# Service Bulletin

Ref. No. **COM-0218 (B056)**

<b>Subject</b>	<b>Note when releasing the paper jam/maintaining the machine (Prohibition of use of the flammable sprays and liquids)</b>
<b>Model</b>	All models

Subject	Parts Change Information
<b>Model</b>	TASKalfa500ci, TASKalfa400ci, TASKalfa300ci, TASKalfa250ci, TASKalfa552ci, TASKalfa420i, TASKalfa520i, TASKalfa300i, TASKalfa620, TASKalfa820, KM-C2520, KM-C3225, KM-C3232, KM-C2525E, KM-C3225E, KM-C3232E, KM-C4035E, TASKalfa550c, TASKalfa650c, TASKalfa750c, KM-6030, KM-8030, FS-C8100DN, EP C320DN, FS-C8500DN, FS-C2026MFP, FS-C2126MFP, FS-3040MFP, FS-3140MFP, DP-700, DP-750/DP-750(B), DP-760/DP-760(B), AK-470

**FIG.20 MPT Assy (KM-C2520/C3225/C3232/C2525E/C3225E/C3232E/C4035E)**

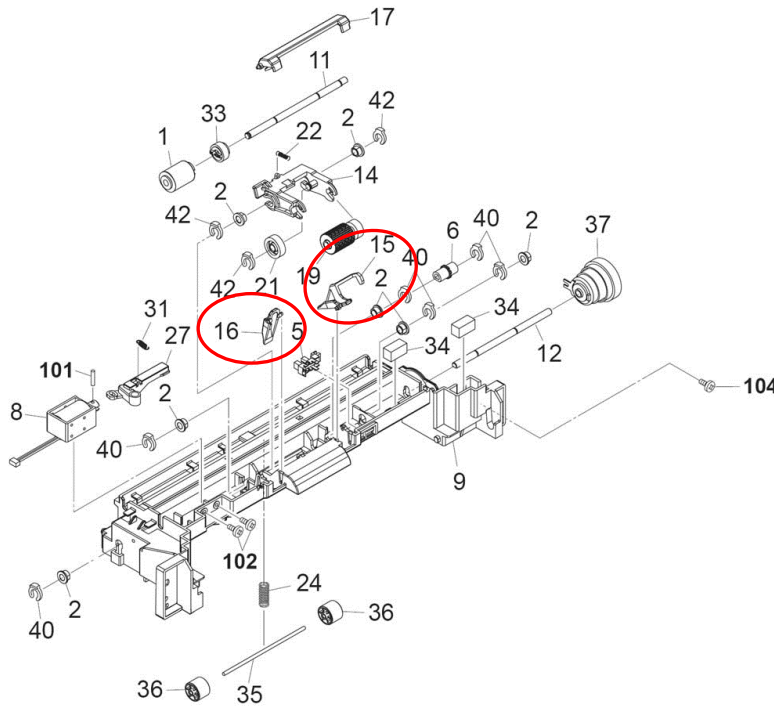
**FIG.18 MPT Assy (FS-C8100DN, EP C320DN)**

[Wrong]

[Correct]

**<Change of the power cord caution label --> After using up the old stock>**

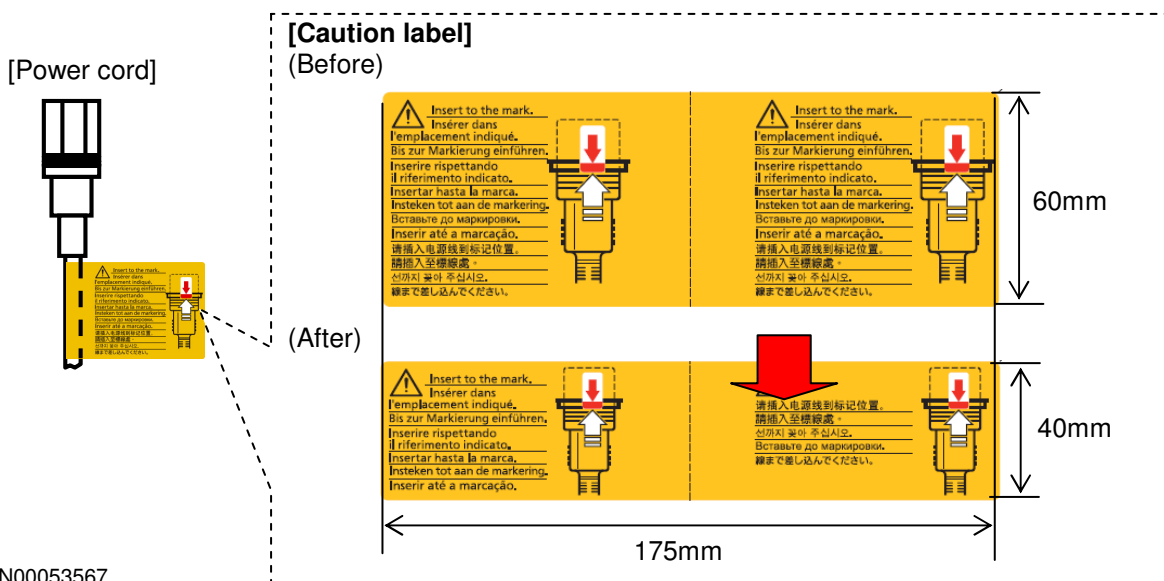
For improving the assembly process, the caution label affixed to the power cord is changed as below. The parts number remains unchanged according to this change.

- 1) Change of the size. (Height: 60mm --> 40mm)
- 2) Relocation of the caution contents according to the above change. (Contents remain unchanged.)

### <(PF-800) Improving paper guide for supplying paper

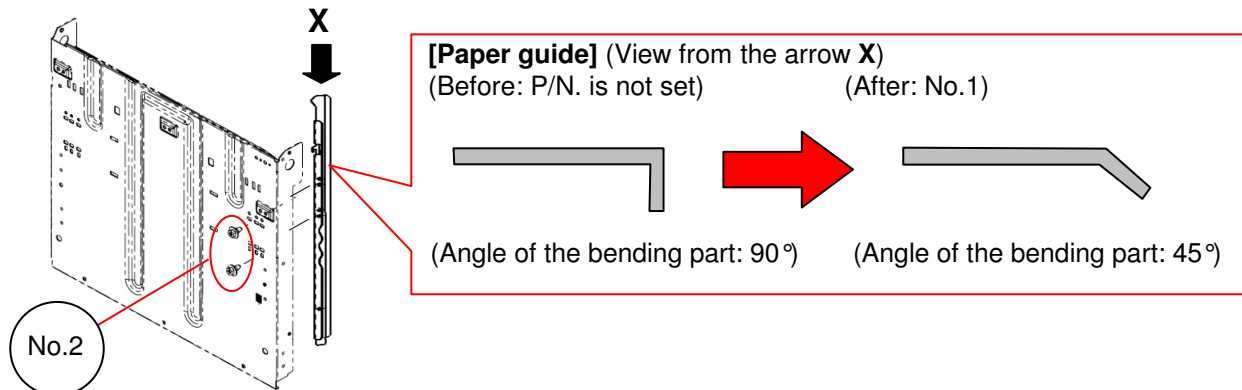
\*1: Paper guide has been used since the 1st production. However, the parts number of the new paper guide is set and it is supplied according to this change.

(All q'ty to use in Fig.6 where No.2 are added is changed from 23 pcs to 25 pcs.)

<b>Subject</b>	<b>(DF-800/810) Note when replacing the parts (Change of the upper ejection roller)</b>
<b>Model</b>	<b>TASKalfa550c, TASKalfa650c, TASKalfa750c</b>

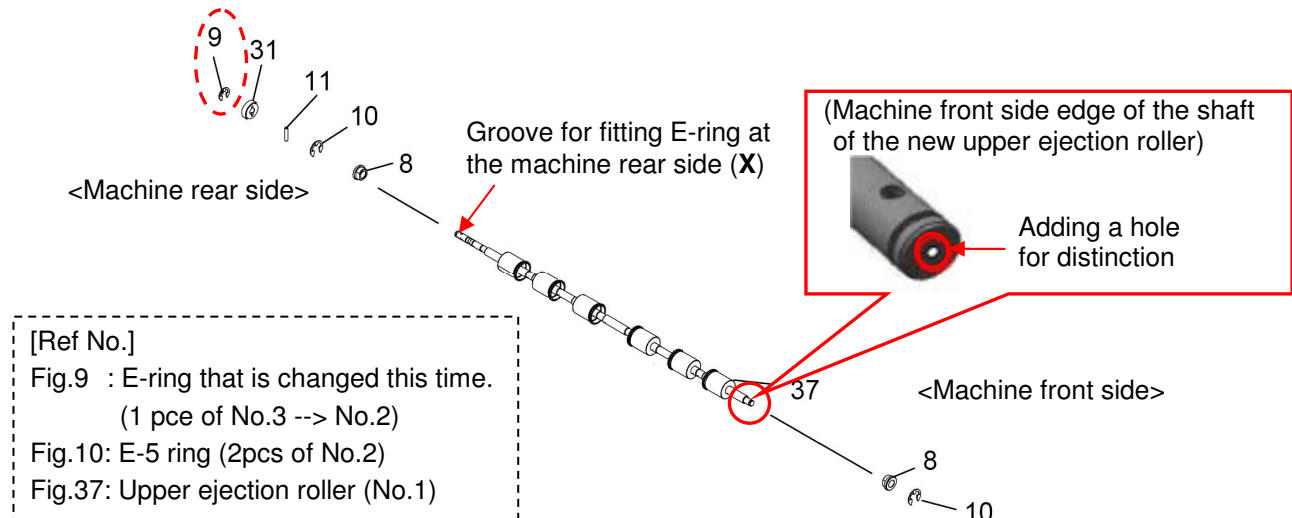
- 1) Diameter of the groove (X) for fitting E-ring at the machine rear side of the upper ejection roller (No.1) is widened.
- 2) According to the above change 1), inner diameter of E-ring at the machine rear side of the upper ejection roller is changed from 4mm to 5mm. (No.3 --> No.2)
- 3) A hole for distinction is added to the machine front side edge of the shaft of the upper ejection roller (No.1) because the new roller becomes incompatible with old E-ring (No.3) according to this change. (The parts number of the upper ejection roller (No.1) remains unchanged because distinction of new or old roller is possible by adding a hole.)

\*1: The parts number remains unchanged according to this change. Please use proper E-ring (No.2 or No.3) at the machine rear side of the upper ejection roller by the presence of a hole so the hole for distinction is added to the machine front side edge of the new upper ejection roller.

**[Cross section of tray unit standby side]**

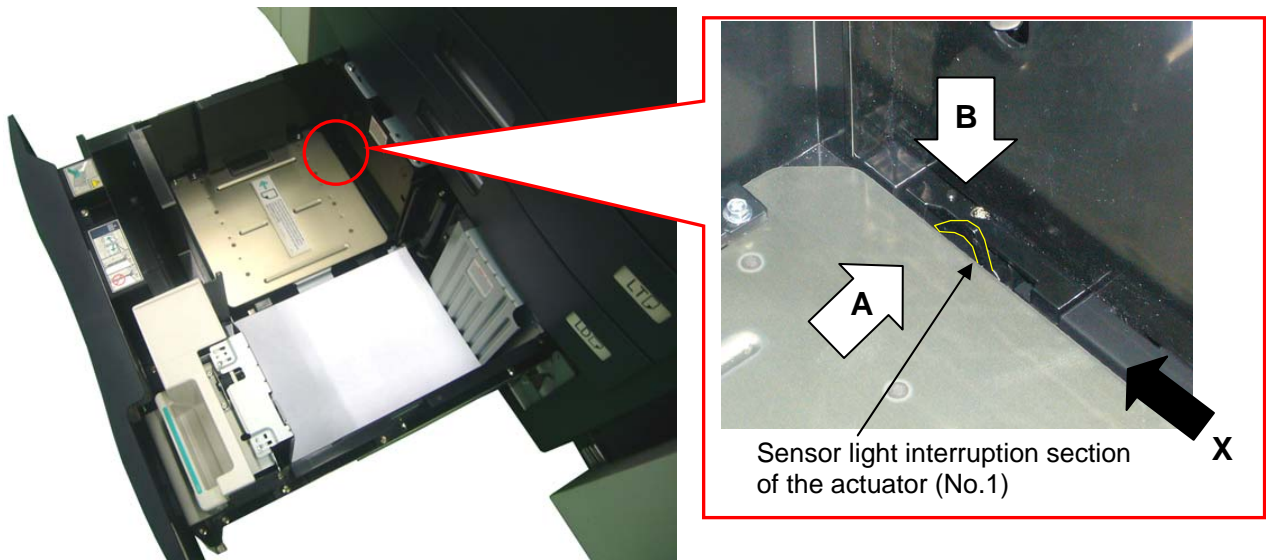
- \*1: Q'ty to use of the screw for securing the sensor cover (No.2) is changed from 2 pcs to 1 pce.  
 (Whole q'ty to use of No.3 in Fig.13 TANDEM-LCF-1-ASM of Parts List is changed from 31 pcs to 30 pcs.)
- \* Old actuator (No.1) can be fitted for the new type machine from the viewpoint of the fitting compatibility. However, its compatibility is set as "X" in the above because the performance is deteriorated to the state before the tolerance for motion of the actuator is improved.

\* If supplying the paper by putting it down from upper side (**B** direction in the above figure), the paper surely takes over the actuator and the actuator can be correctly operated when the paper becomes empty.

<b>Subject</b>	<b>Disuse of the skirt cover</b>
<b>Model</b>	<b>TASKalfa550c, TASKalfa650c, TASKalfa750c</b>

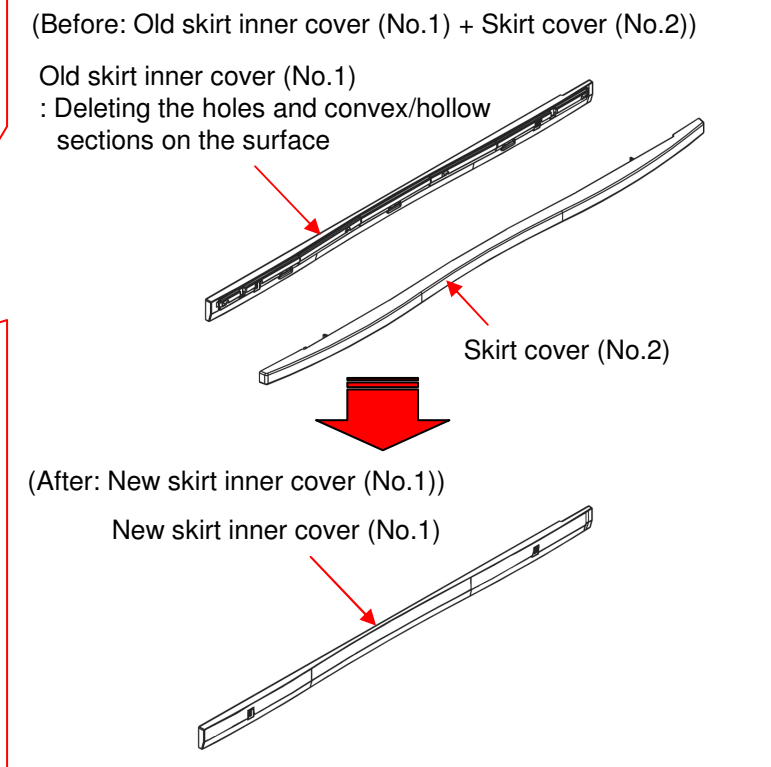
Following are changed to prevent the skirt cover (No.2) at the lower section of the machine from stepping on and contacting with the bump on the floor, the obstacle, etc when opening/closing the tandem LCF or relocating the main machine, etc.

(If strongly stepping on/contacting the skirt cover, the skirt inner cover (No.1) or the skirt cover (No.2) may be damaged.)

<b>Subject</b>	<b>Improving the process unit installation (note when replacing the EPU drawer lock lever)</b>
<b>Model</b>	<b>TASKalfa550c, TASKalfa650c, TASKalfa750c</b>

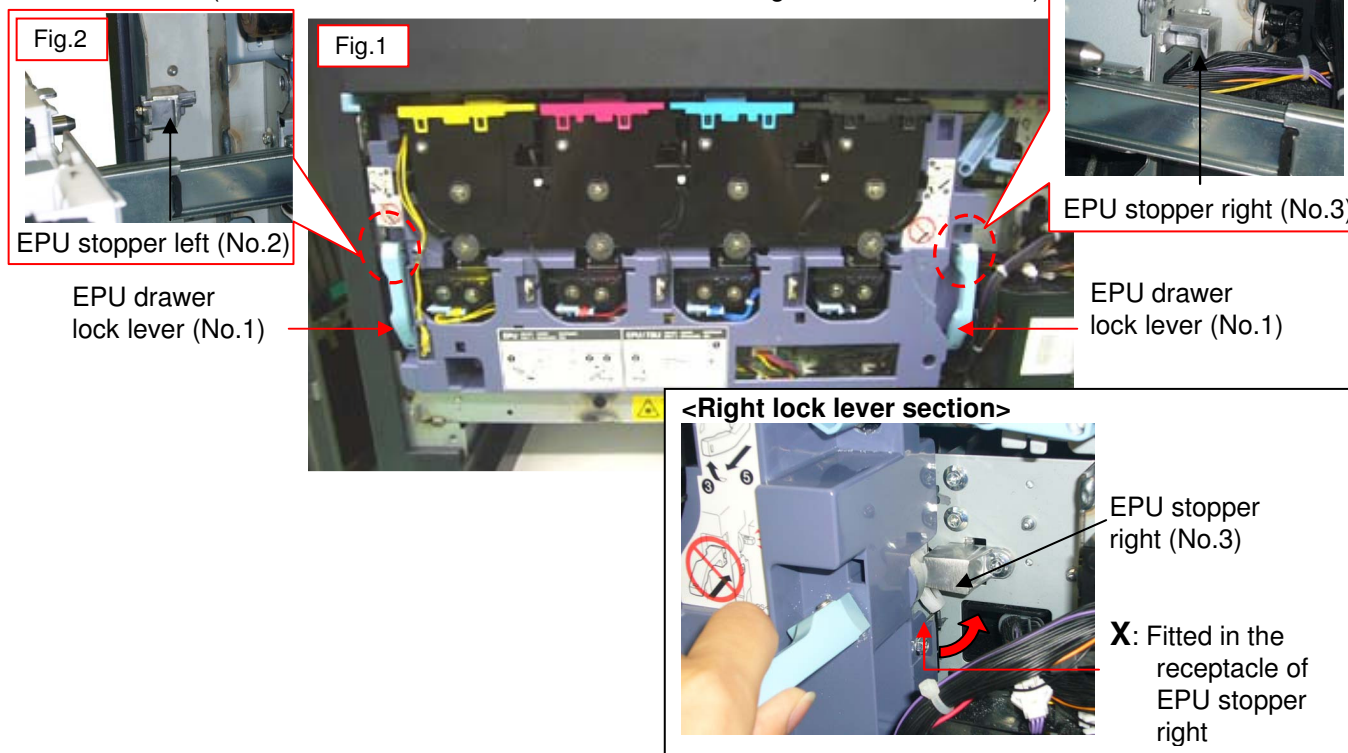
If the EPU drawer lock lever (No.1) is set to the lock position while the process unit is incompletely installed toward the machine rear side when installing it in the main machine, there may be poor joint between the waste toner vent at the process unit and the waster toner conveying vent at the main machine side and a small amount of waste toner may leak. Therefore, following are changed.

<b>KMC's Classification</b>	<input type="checkbox"/> Entire Stock Rework	<input type="checkbox"/> In-Field modification at next visit
	<input type="checkbox"/> In-Field modification by case	<input checked="" type="checkbox"/> No modification necessary
<b>Field Measure:</b> Please use the set of the new or old parts (No.1 to 3) when replacing the parts.

**<Lower guide section>** (Conveying rollers, actuator and conveying film are fitted)

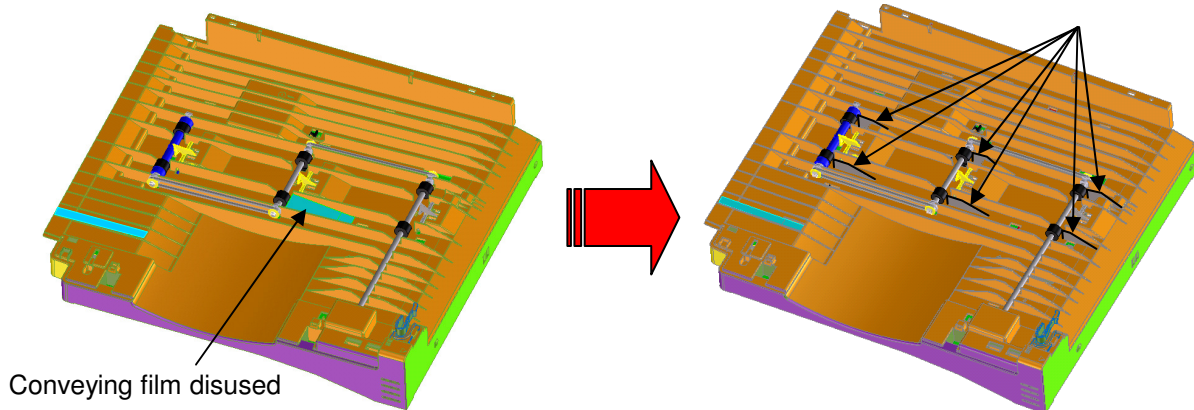
6 points of conveying ribs are added to the lower guide (\*) of the bridge unit (AK-470) and the conveying film (\*) is disused that is affixed before the center conveying roller in order to improve assembly process.

(\*) Lower guide and conveying film is not parts for field supply.

### <Assembly process improvement → Available from April 2011 production>

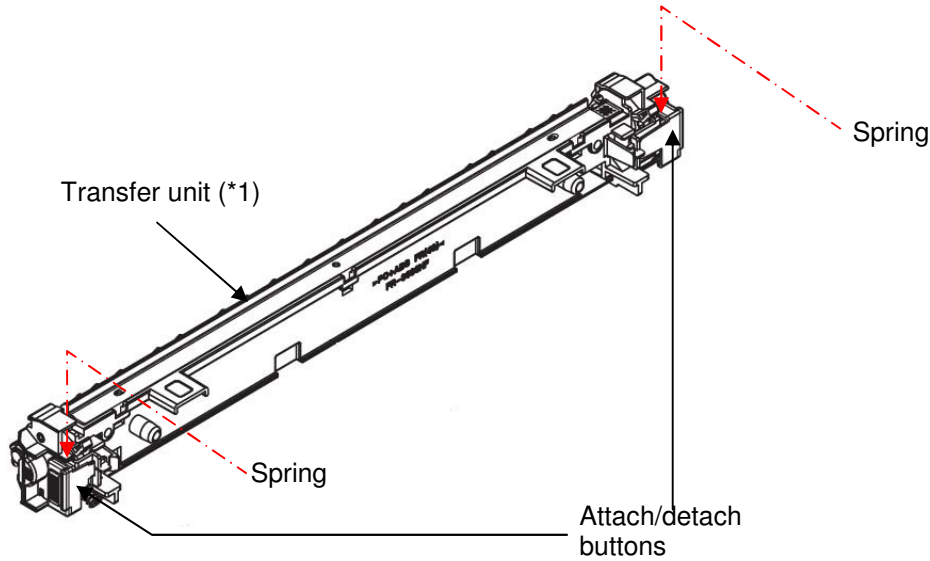
The springs in the attach/detach buttons of the transfer unit are disused since it is confirmed no problem in functionality. The part number remains unchanged after this change.

**FIG. 11 FEED-ASM**

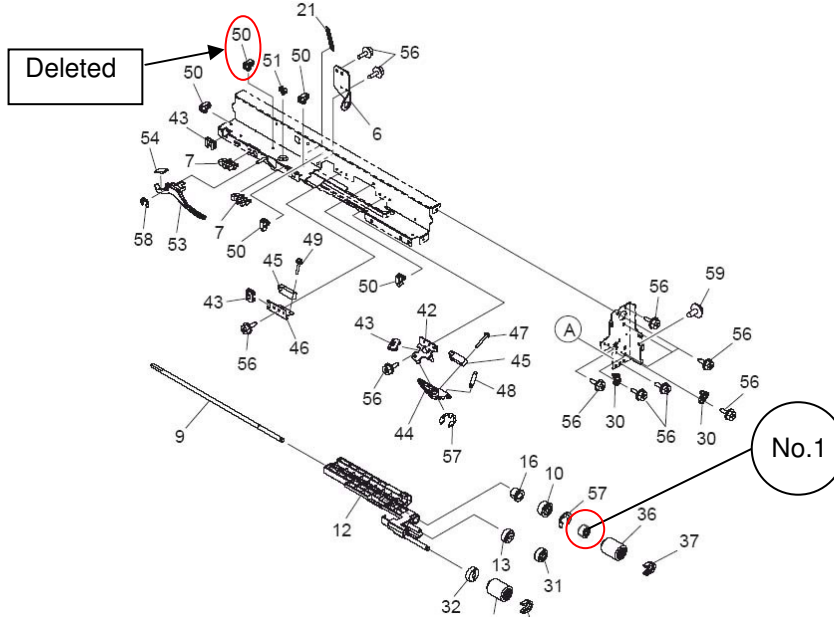
The illustration part and qty to use in the parts list are corrected as follows.  
The following part (No.1) is also set to the one for the field supply.

[Wrong]					[Correct]		
Fig.	Ref.	Part No	Part name	Qty	Part No	Part name	Qty
11	50	305JN72KG0 5JN72KG0	CLAMP:LBWS-0206S-V0	5	305JN72KG0 5JN72KG0	CLAMP:LBWS-0206S-V0	4

**[Change A] ---Applied parts No1 to 5**

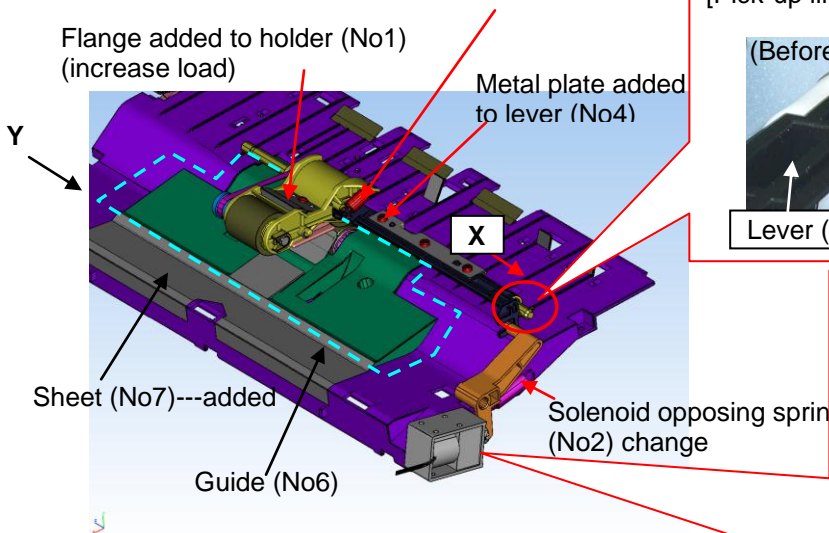
Pick-up roller tension spring (No3) change

**[Pick-up lifter link part shape change]---viewed from X**

**[Change B]--- Applied parts No6 to 11**

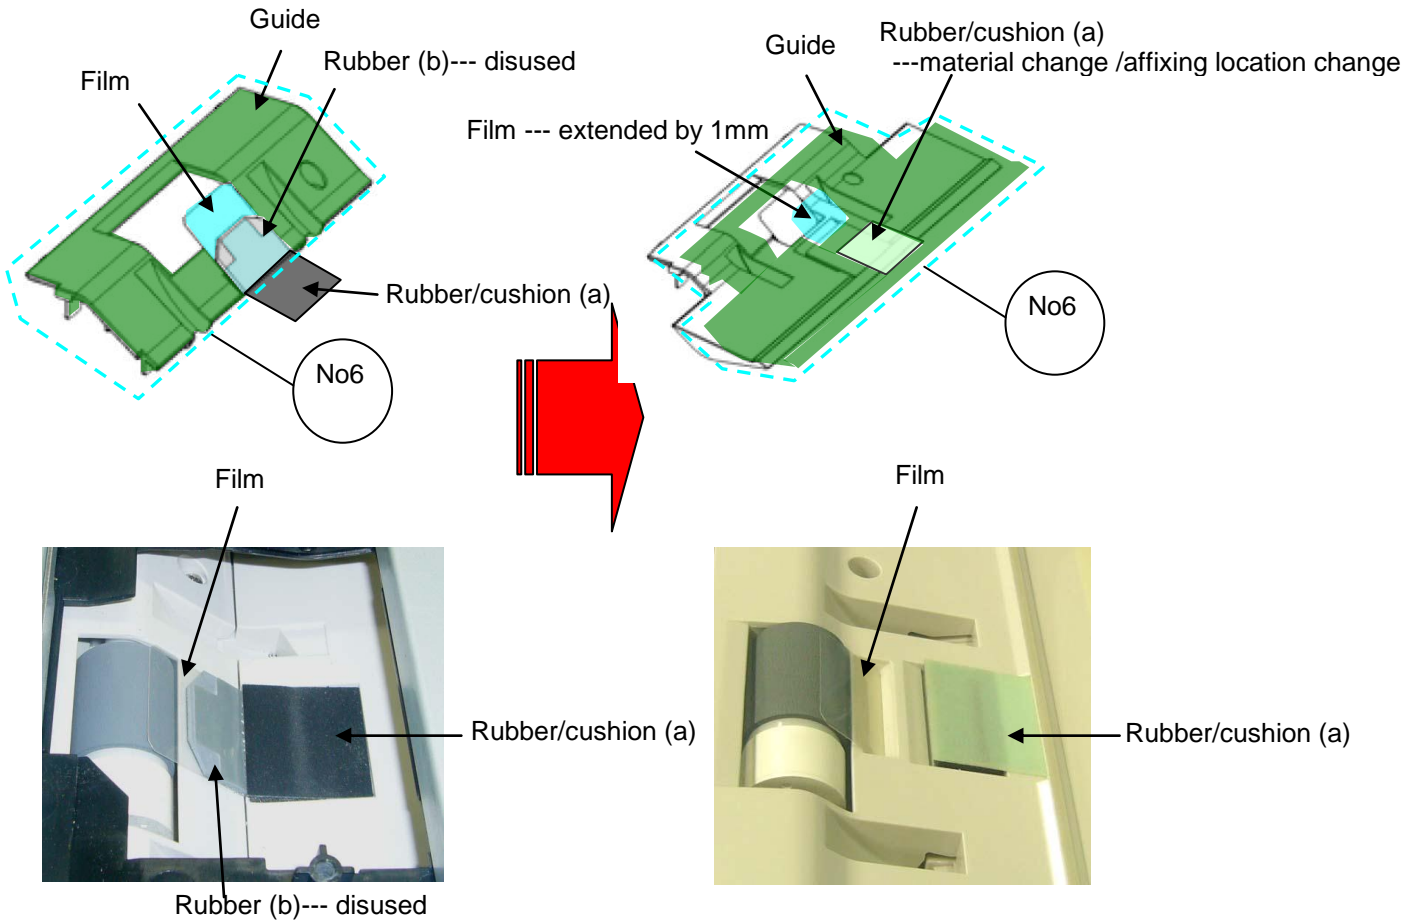
[Guide (No6) changed]---viewed from Y

**<(South America spec) DP label set-up → Applied since the 1st production>**

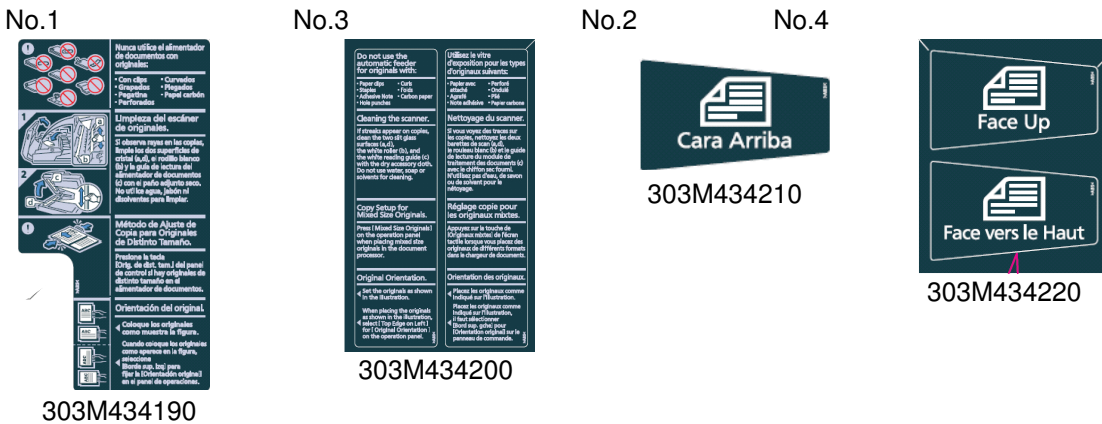
The label for the standard DP for South America is set up and bundled.

## <GEAR Z20 JOINT fitting improvement>

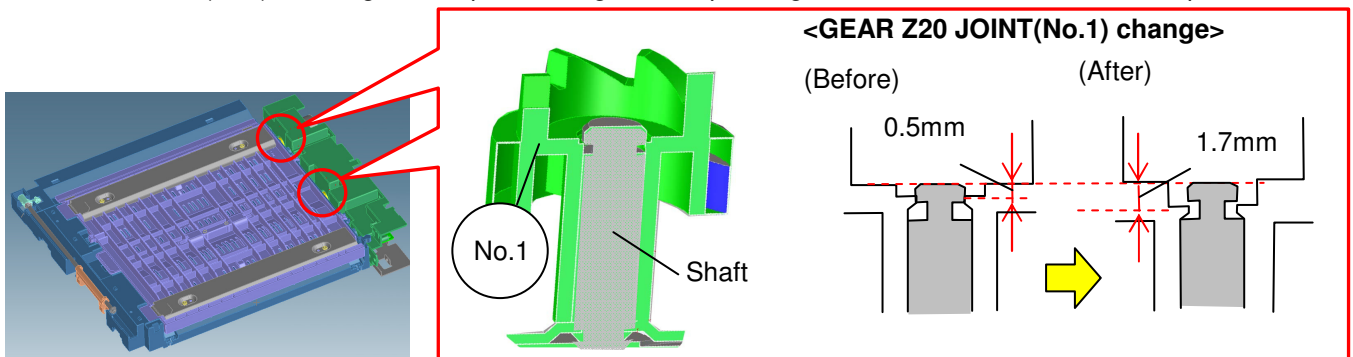
GEAR Z20 JOINT(No1) is changed to improve fitting ease depending on dimensional tolerance of the part.

**FIG. 63 CLEANER-ASM**

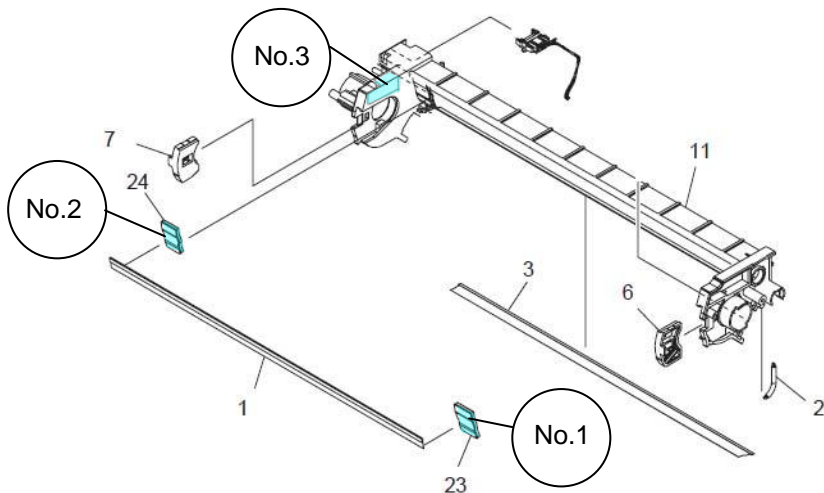
The following parts (No.1 to 3) for the drum cleaning unit are changed for common use. The film (No.3) that is not for field supply is set up for the service parts this time.

**[No.1,2 change]**

**FIG. 63 CLEANER-ASM**

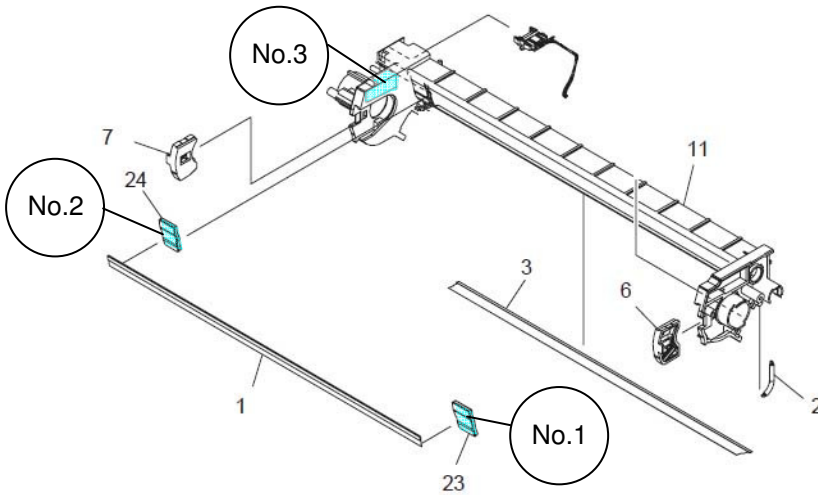
The following parts (No.1 to 3) for the drum cleaning unit are changed for common use with other models. Also, the film (No.3) is set up for the service parts that is not for field supply.

**[No.1,2 change]**
